PLANNING, ZONING, & BUILDING DEPARTMENT
PZ&B Staff Combination Memorandum: Architectural Commission and Town Council

SUBJECT: ARC-23-145 (ZON-23-113) 123 CHILEAN AVE (COMBO)

MEETING: FEBRUARY 28, 2024, ARCOM
MARCH 13, 2024, TC

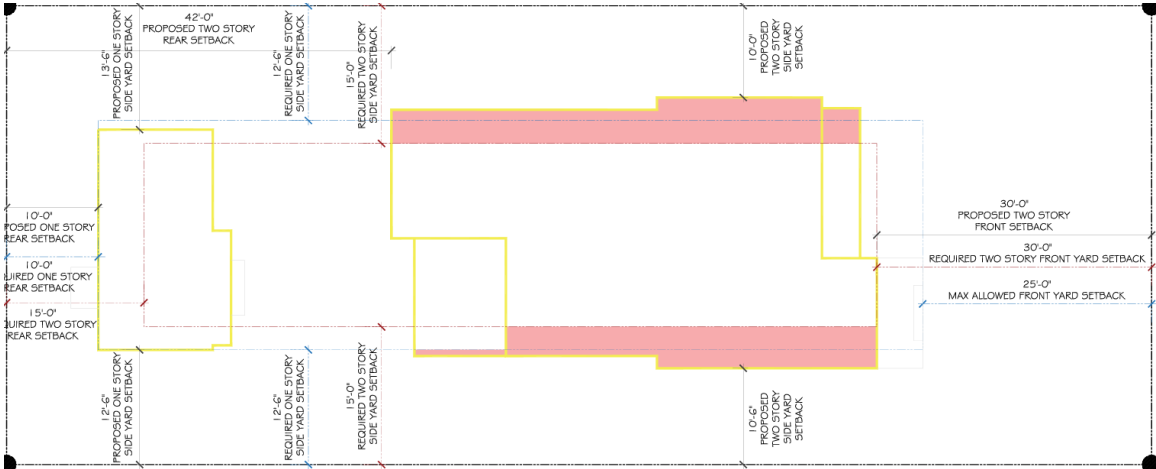
The applicant is proposing the construction of a new two-story residence with detached one-story guest house cabana structure. The primary structure is a condensed stylized version of a Monterey house with a cantilevered balcony on the front elevation that faces south. The front entry has been redesigned to feature a rectangular door with transom light and a front facing gable above. Windows are primarily 6/6 Hartman Mahogany sash windows depicted with white frames. Smooth stucco, shutters and wood detailing completed the finishes. The rear detached cabana which features a single room plus bathroom has side facing gables. Both structures are proposed to have a flat white concrete tile roof. There is a mix of one- and two-story single-family residences on the north side of this block, however, almost all single-family homes on the other side of the street are two story with very similar massing. The applicant has revised the arrangement of openings on the balcony to feature a pair of French doors flanked by 4/4 sash windows. The gable on the primary façade has been widened. The building height

has been lowered from 20'-10" to 20'-4", however, the overall building height has been raised from 27' to 27'-7" to the top of roof, with a change of roof pitch. The arrangement of columns at the rear loggia has been redesigned with corresponding changes to the railings above. Small adjustments have been made to the arrangement of fenestration on the east and west sides of the structure. Adjustments were also made to the landscape plan. No changes were made to the detached cabana structure.

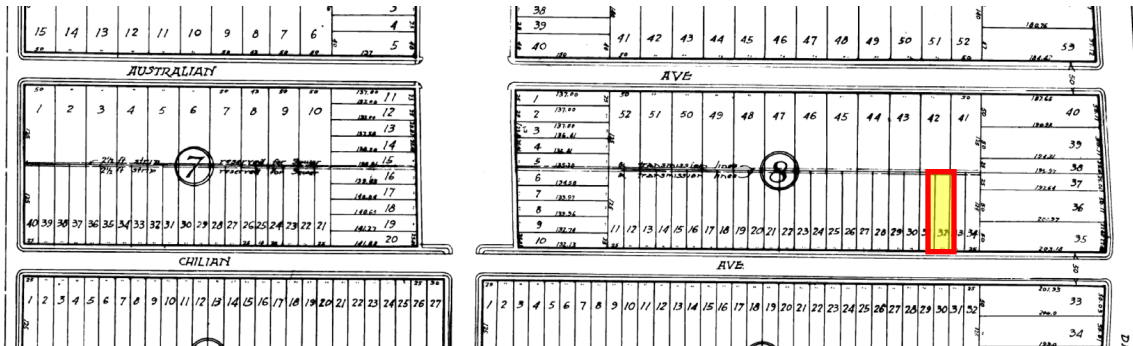
The application as presented requires 3 variances for construction, one for the west side yard setback, one for the east side yard setback, and one to exceed maximum cubic content. The lot is a substandard size for the district (special exception required) at only 50 ft in width. The applicant is proposing a 10' east side yard setback, and a 10.5' west side yard setback. The proposed cubic content ratio is 4.66 in lieu of the 4.38 maximum permitted, an excess of 1750 cubic feet. The diagram below highlights the portion of the proposed main structure which violates the setback requirements.
